## SERVICE BULLETIN

**APPLICABILITY:** Legacy and Outback 2000-2009MY w/ 5MT  
 Forester 1999MY and Later w/ 5MT  
 Impreza (Including WRX) 1999MY and Later w/ 5MT

**NUMBER:** 03-70-12  
**DATE:** 12/13/12

**SUBJECT:** Repair Procedure for High-Pitched Sound from Extension Housing Area Using Latest Generation Production Parts

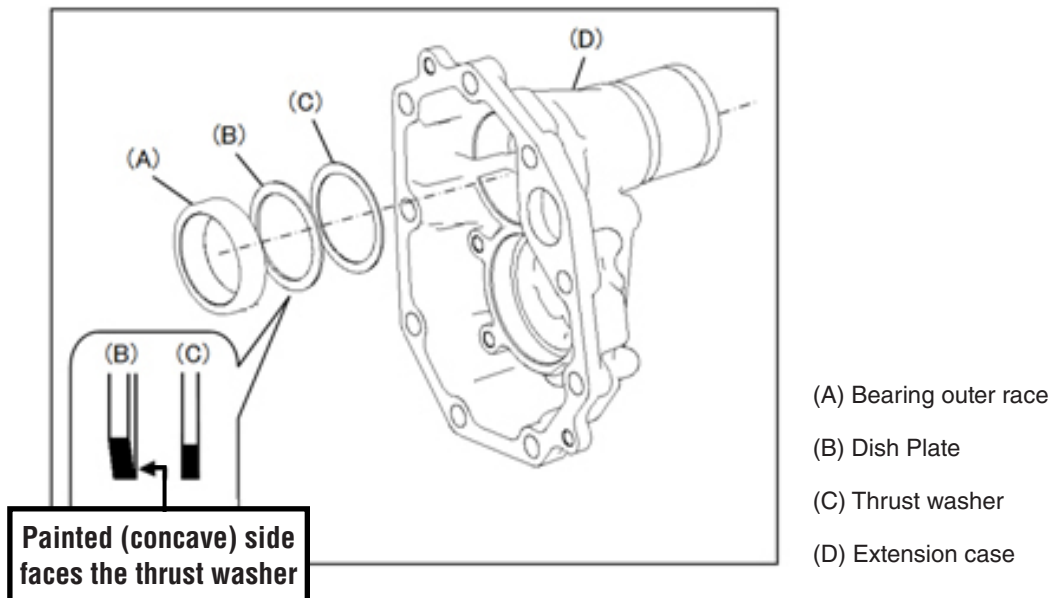
- Follow the procedures in the applicable Service Manual for removal and replacement of the extension housing and replacement of the transfer driven shaft components. The illustration below shows the location and proper installation direction, painted and concave side toward the thrust washer, for the new dish plate.

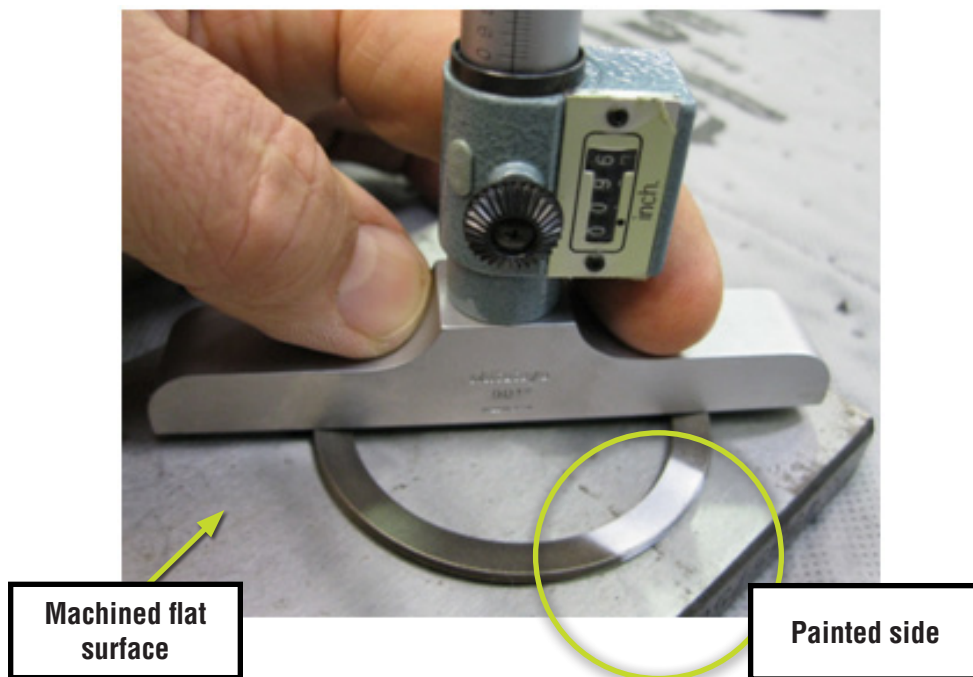
**NOTE:** Although the measurement procedures for selecting the proper thrust washer thickness are unchanged, the dish plate thickness value must be determined and accounted for in your calculations. A method for measuring the thickness is shown in the photo below utilizing a depth micrometer on a machined flat surface. Measure the plate in at least three places then average your results to arrive at the thickness value.
